**MCPB**  
**ITEM #16**  
**10/28/04**

**MEMORANDUM**

**REVIEW TYPE:** Preliminary Plan of Subdivision for 9 single-family detached residential units

**PROJECT NAME:** Briarcliff Meadows North

**INTERCOUNTY CONNECTOR**  
**ICC**  
 October 4, 2004

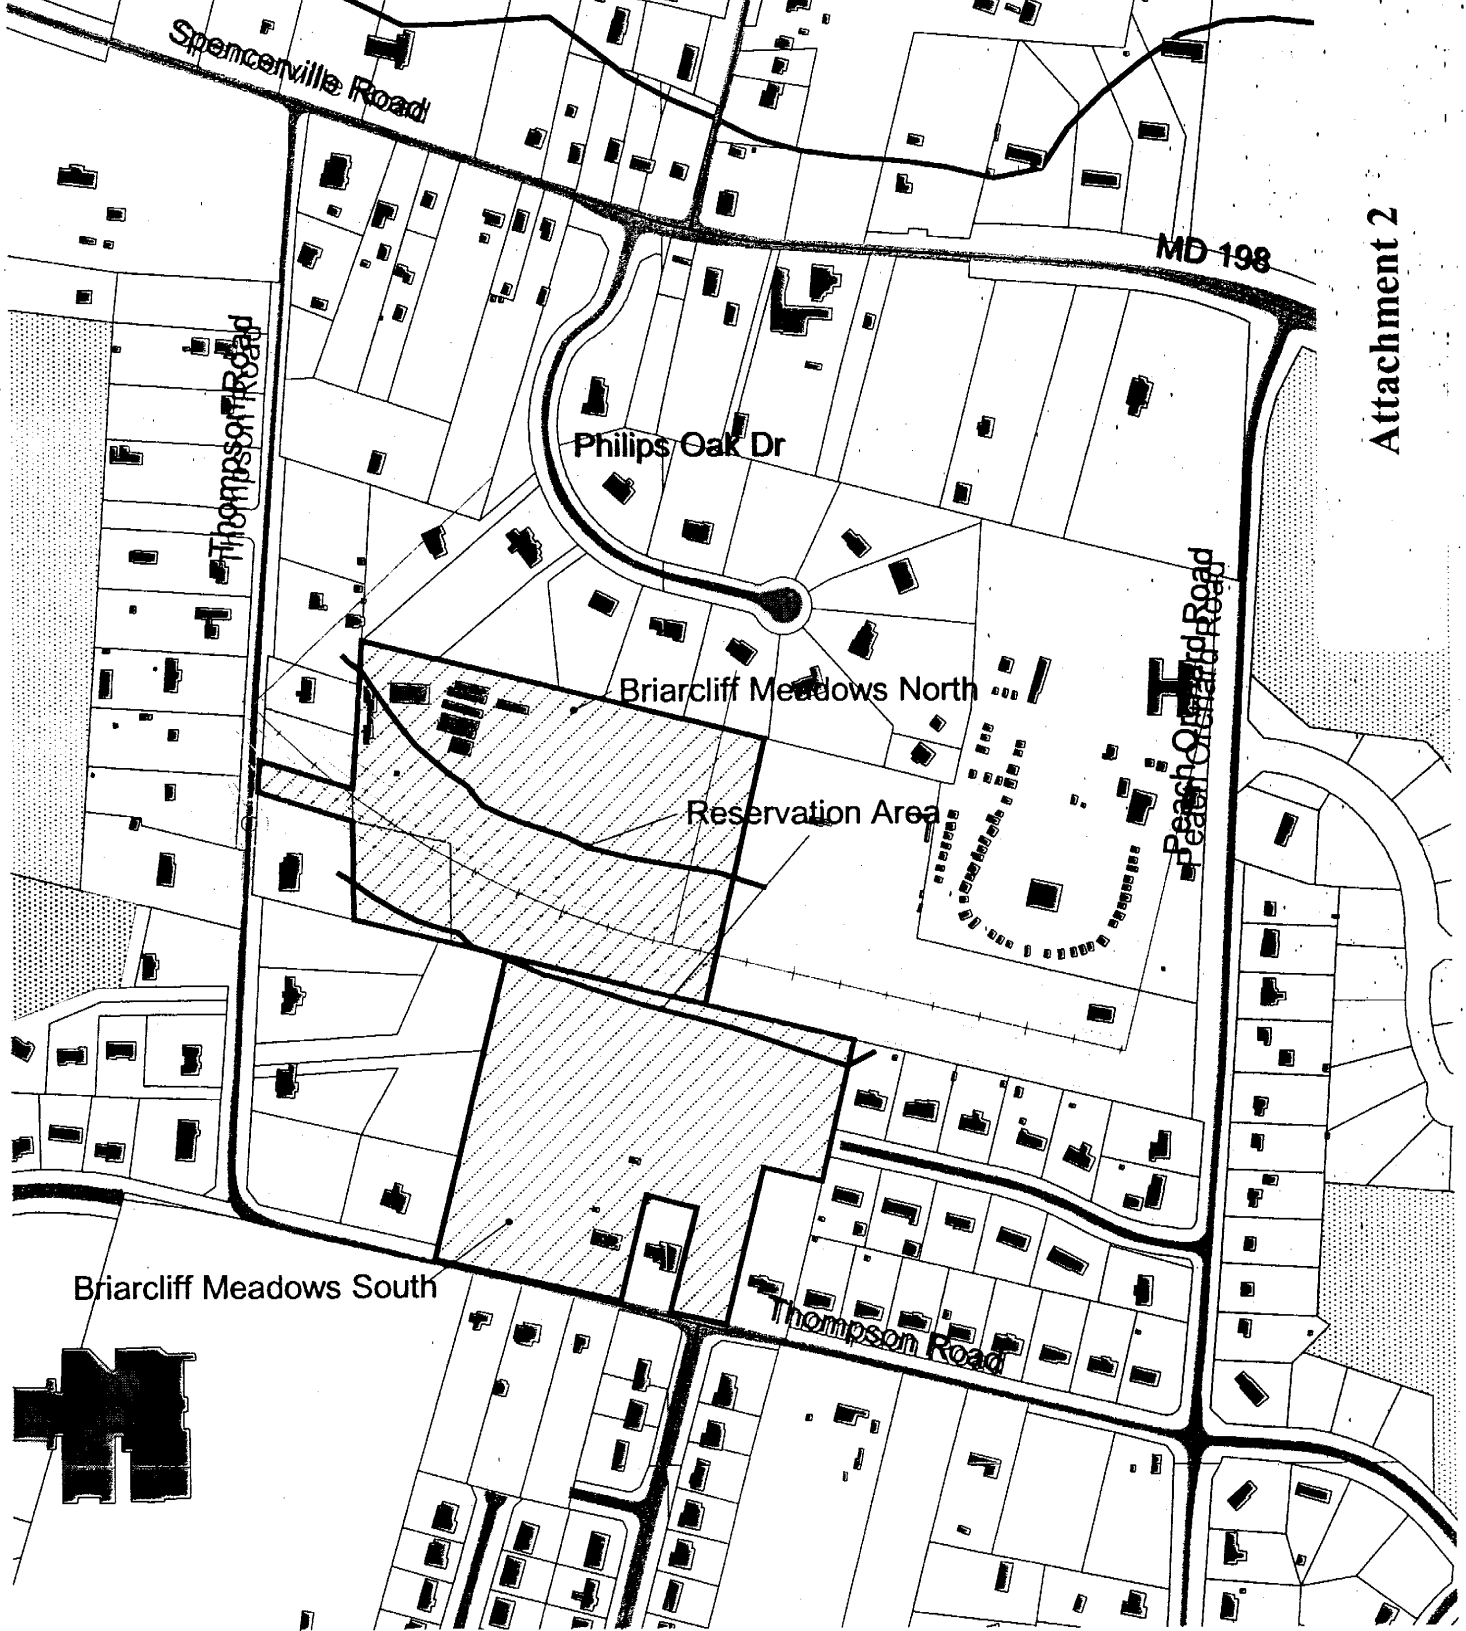
1. Place in reservation the area shown on Attachment 1, dated October 4, 2004 ("Reservation Area") until the earlier of (a) September 1, 2005; or (b) a final Record of Decision is issued by the FHWA, and that Record of Decision does not include the Reservation Area, or any portions thereof, within the final Intercounty Connector (ICC) alignment.
2. Limit any future development on the site as part of the subject Preliminary Plan to nine single-family detached dwelling units.
